CITY PLAN COMMISSION STAFF REPORT

Barrio Major Amendment

CD-CPC-2024-00003

Rezoning to UR – Major Amendment

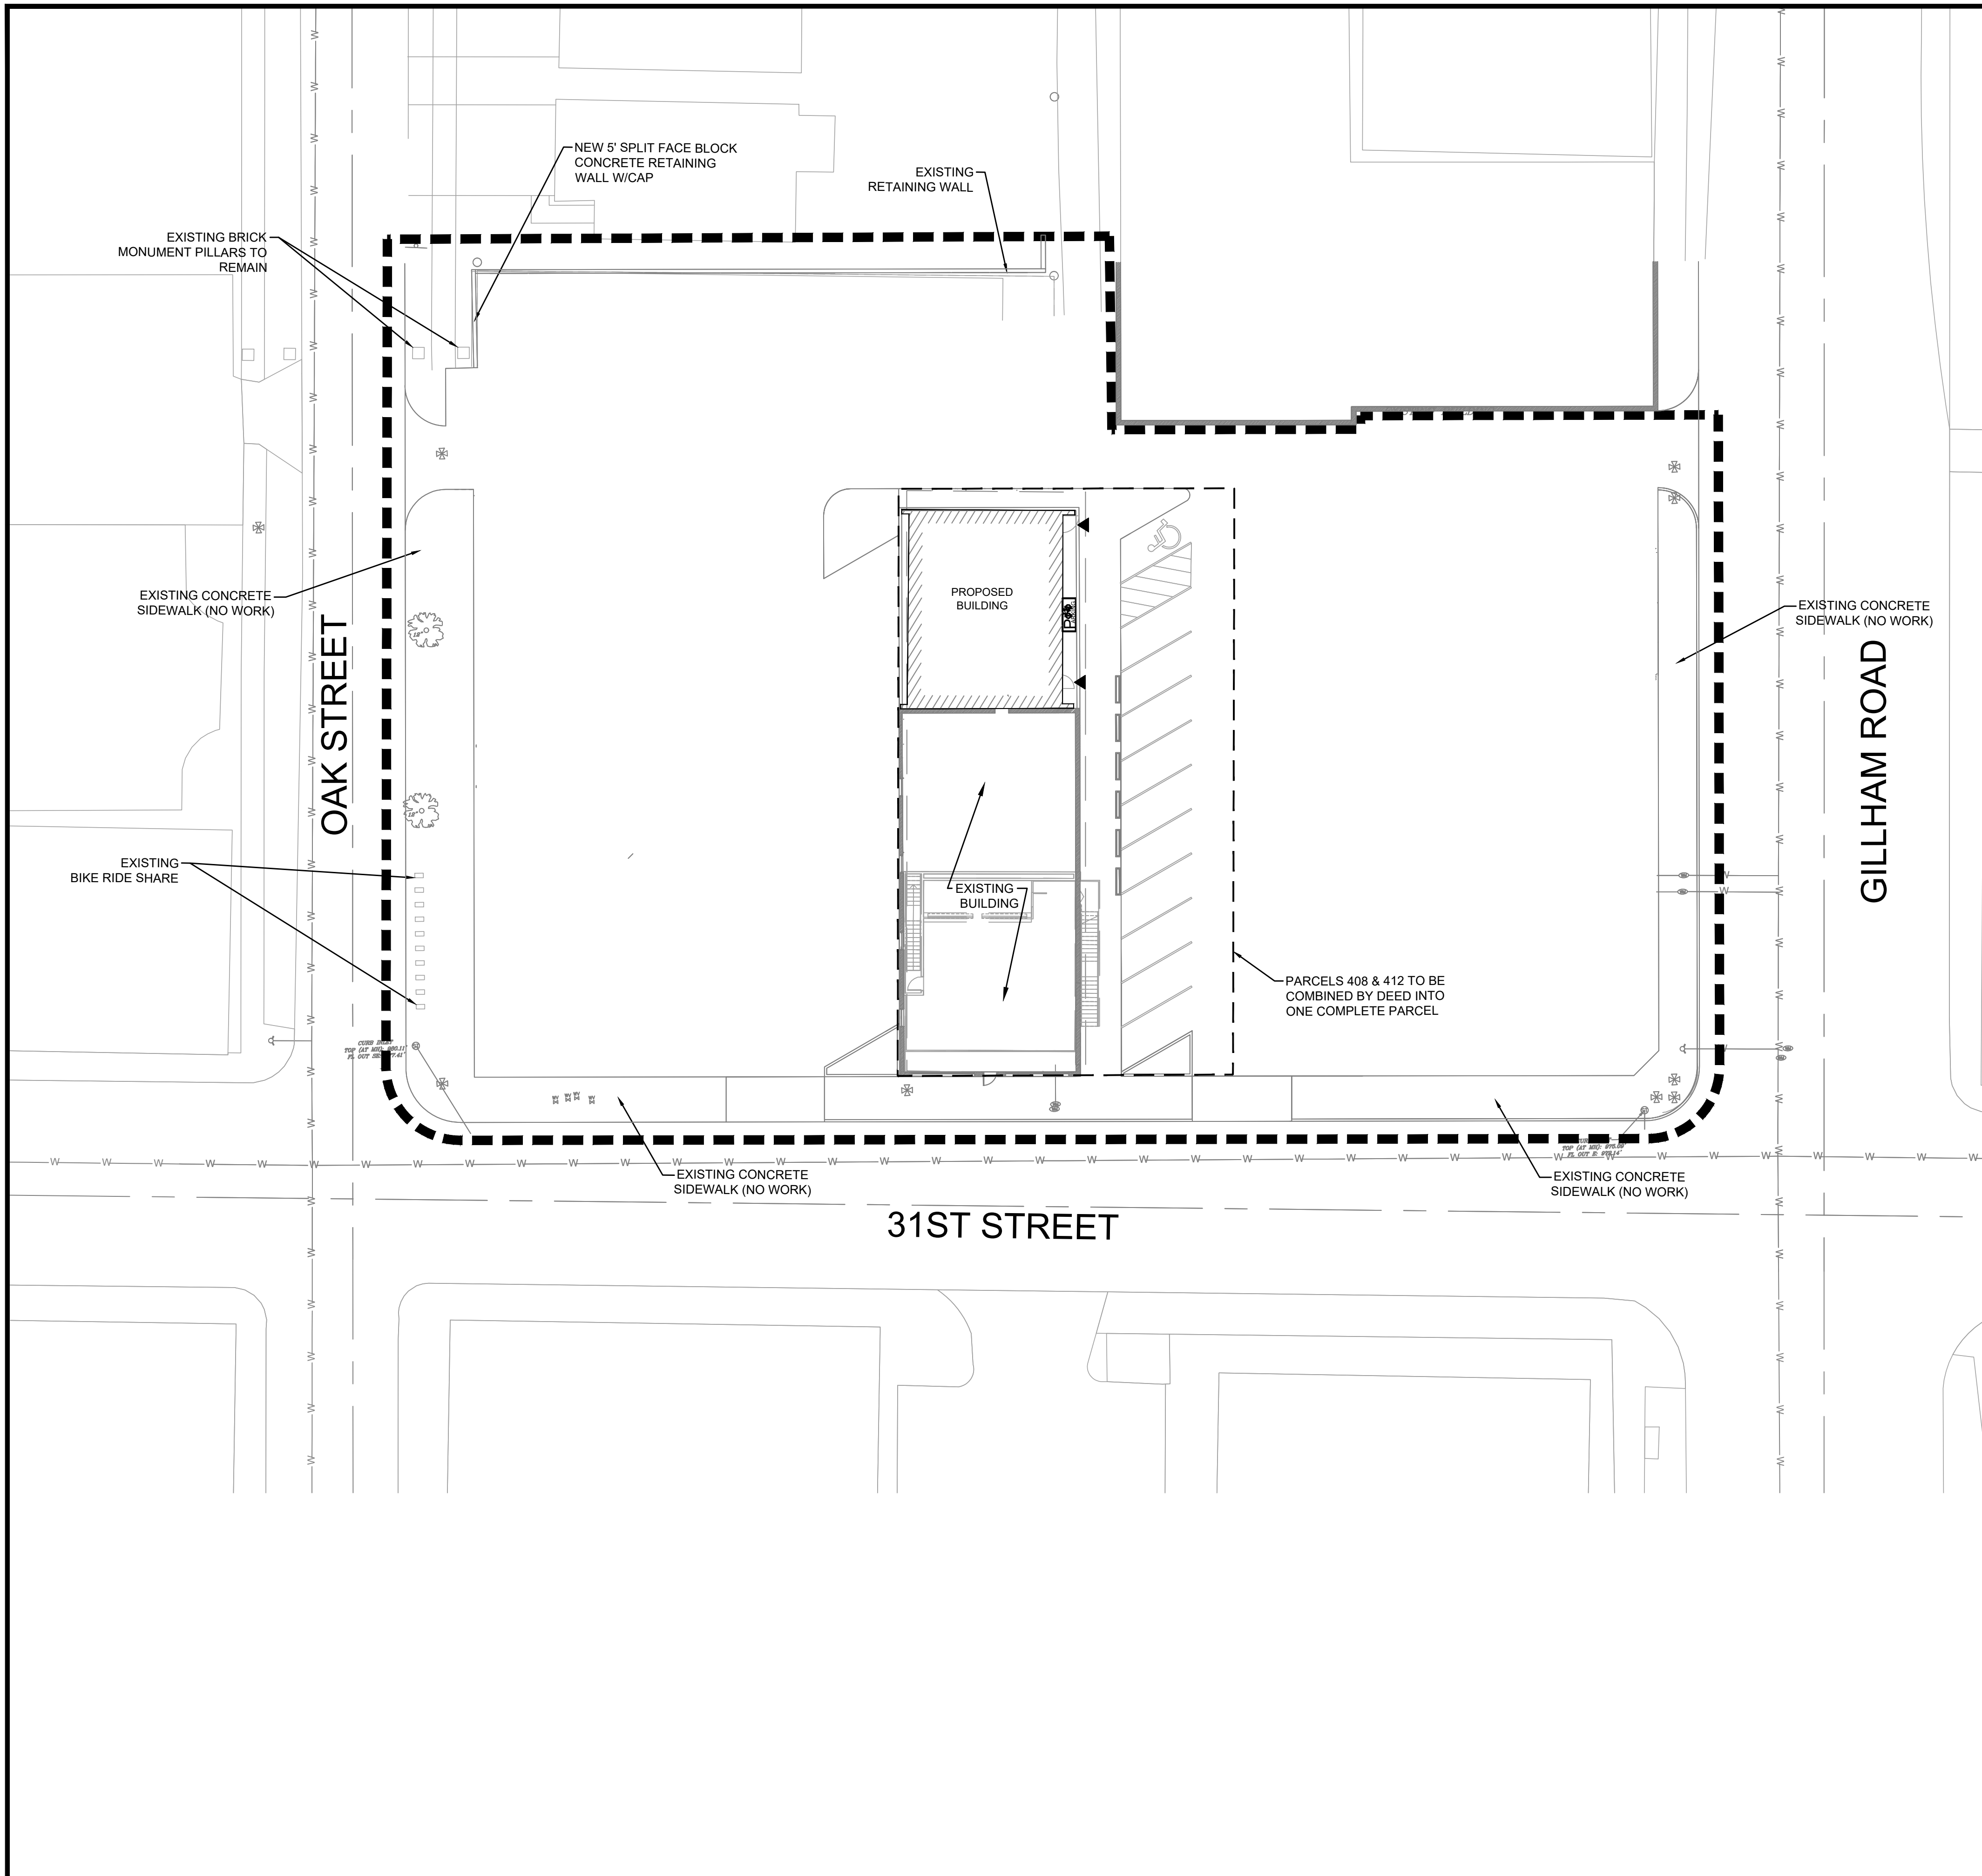
Circulation on the site will remain the same. The parking lot will be restriped to provide angle parking, which will reduce the number of on-site spaces from 13 to 11. The Union Hill UR design standards allow properties located in the Mixed Use Residential Commercial area of the overall UR plan allow for a 50 percent reduction in parking for commercial uses. Based on this reduction, 19 spaces are required for the existing use and approximately 20 spaces are required for the proposed building, depending on the final use. The project has a parking deficit of 26 spaces; however, they also have a shared parking agreement with the adjacent properties. The applicant is requesting a deviation to consider the 11 proposed spaces as compliant.

*Deviation to 88-420-06 to allow 11 on-site spaces to be considered compliant for two commercial tenants. This is a deviation in the amount of 26 spaces.

5. Combine 408 and 412 E 31st Street by deed through Jackson Country prior to building permit.
6. The applicant shall receive approval of a deviation to the parking standards in 88-420 from City Council to allow for 11 parking spaces on-site to serve the existing and proposed uses.
